Project No. 16092
Client Forty Two Point Five Elsworth Ltd
Date July 2018
Scale 1:200 @ A3 / 1:100 @ A1
Project 42 Elsworth Road, NW3

Drawing Title: Demolition Lower Ground Floor Plan
Drawing No. D_02 Rev. A
Drawn RP Approved MW Signed -

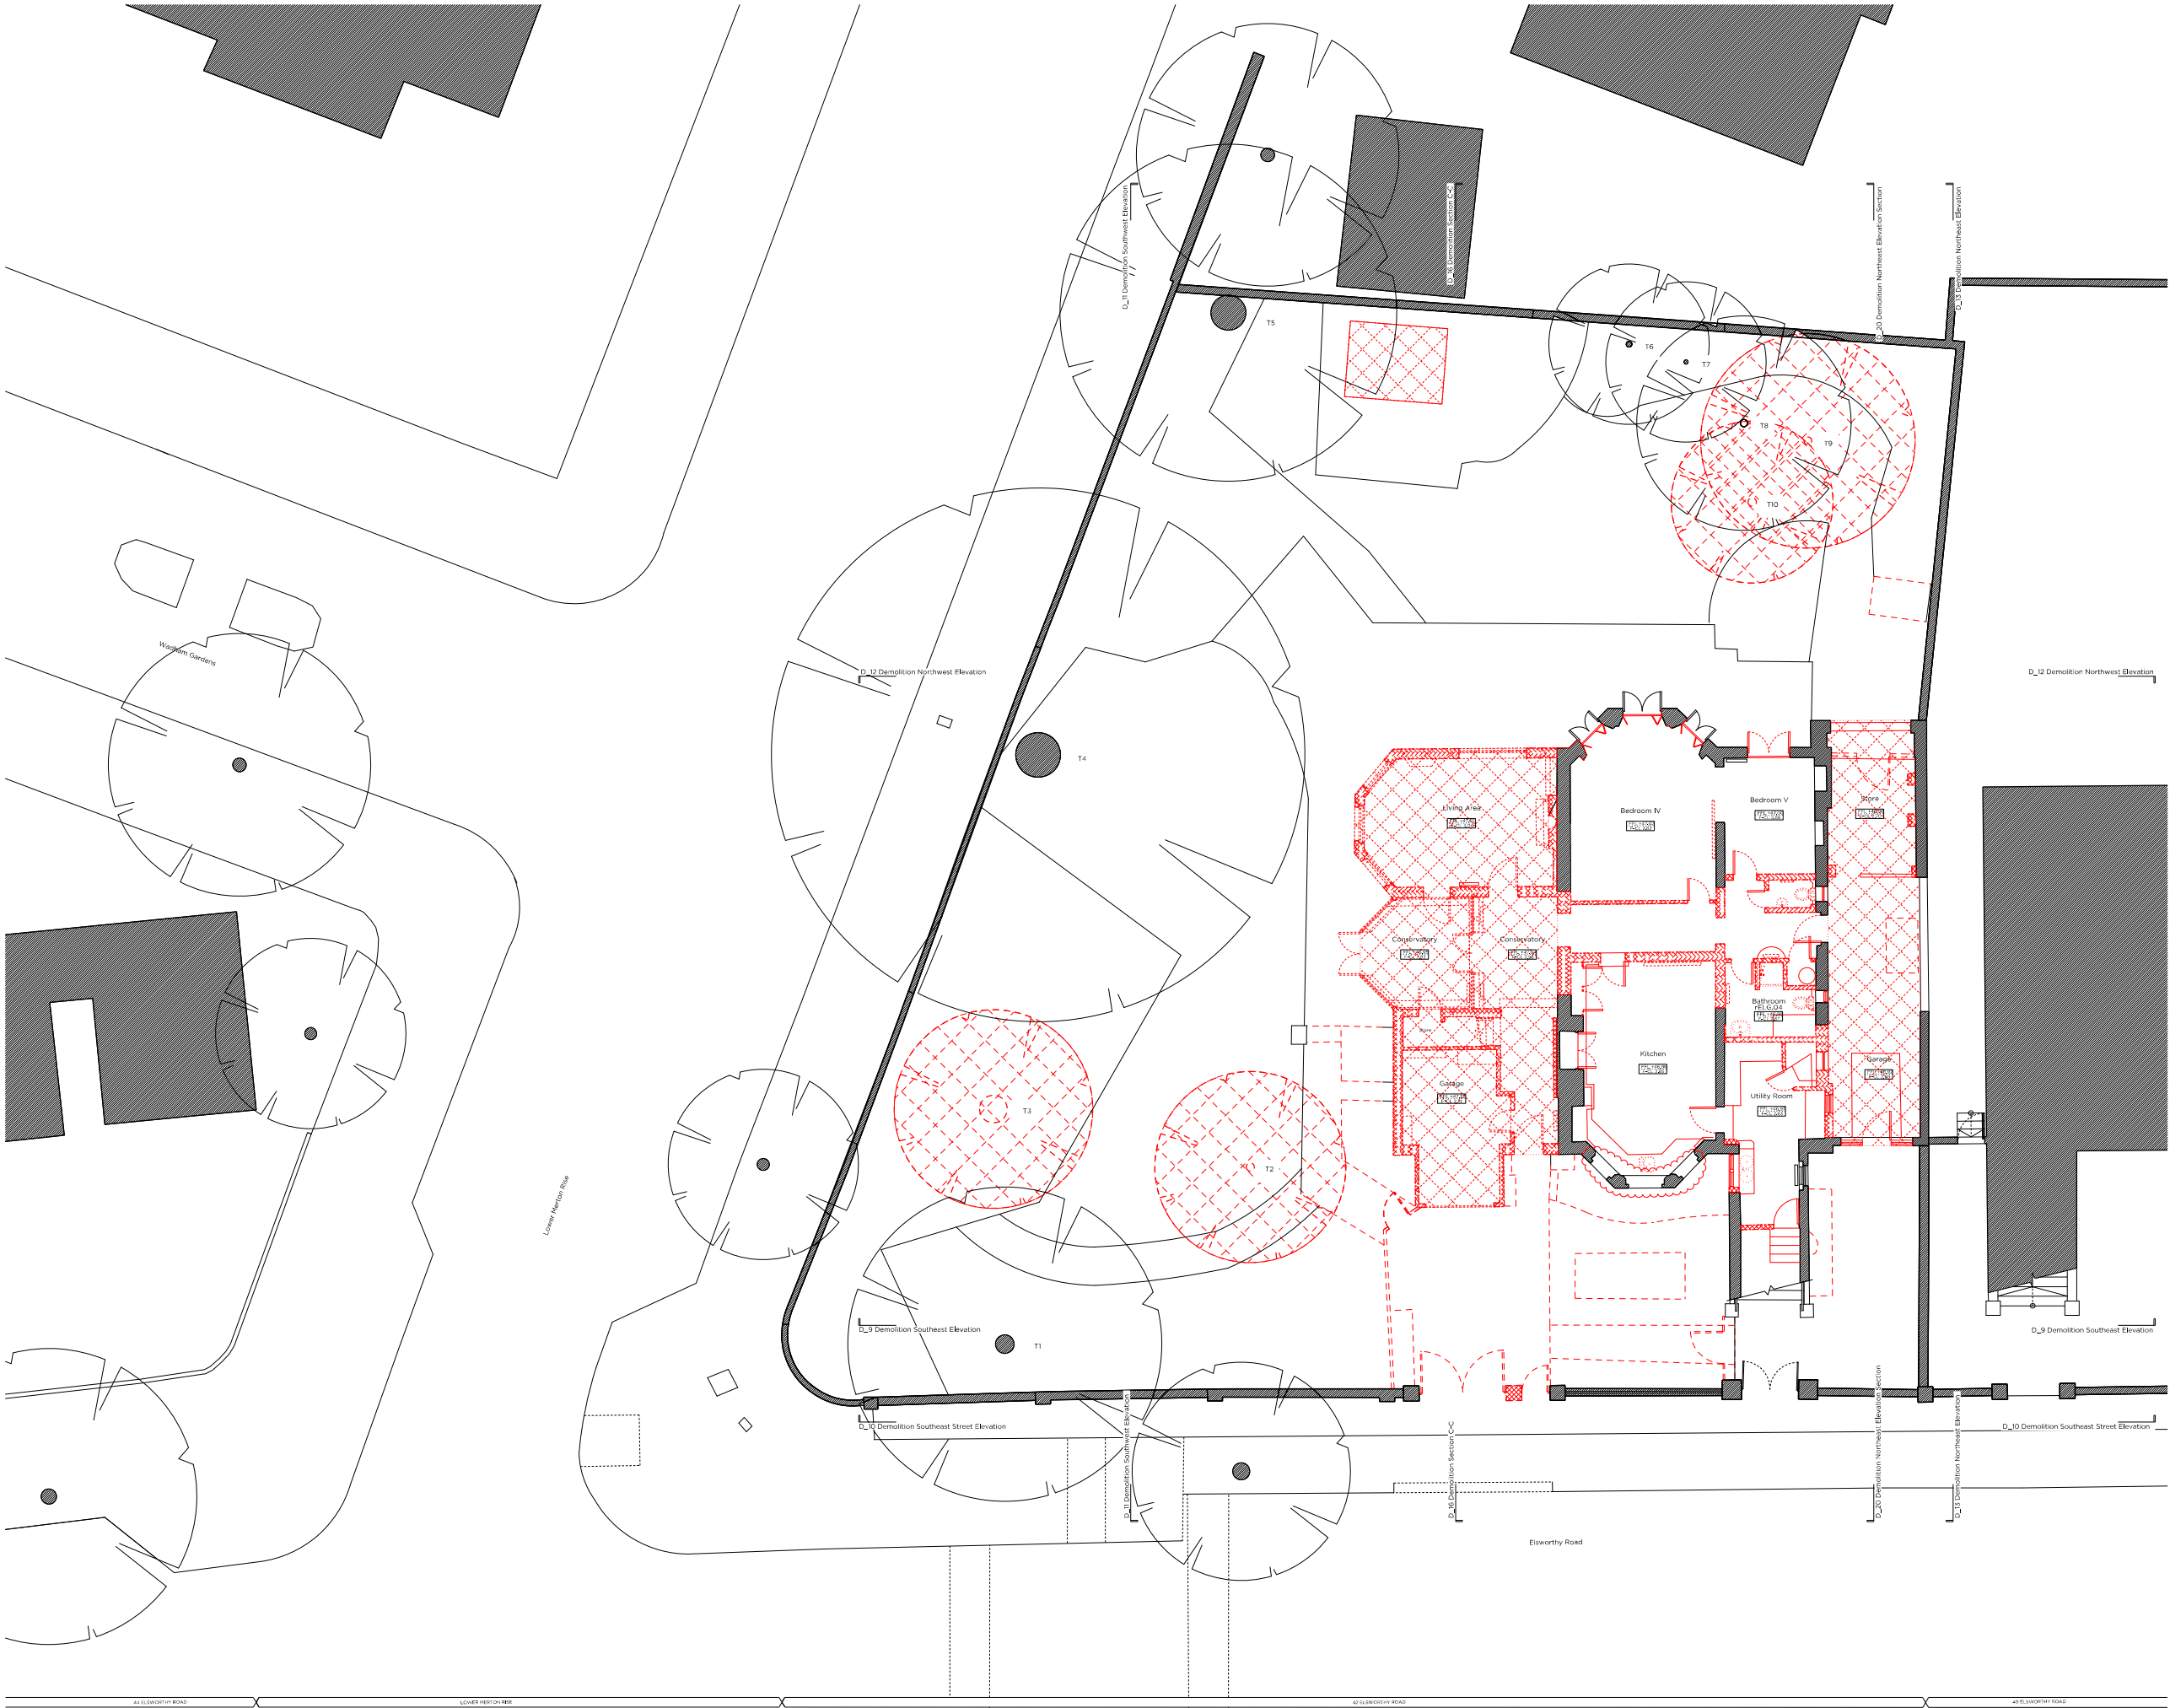
REV: A Revised as bubbled: lowering of
cil to front elevation sash windows
has been omitted
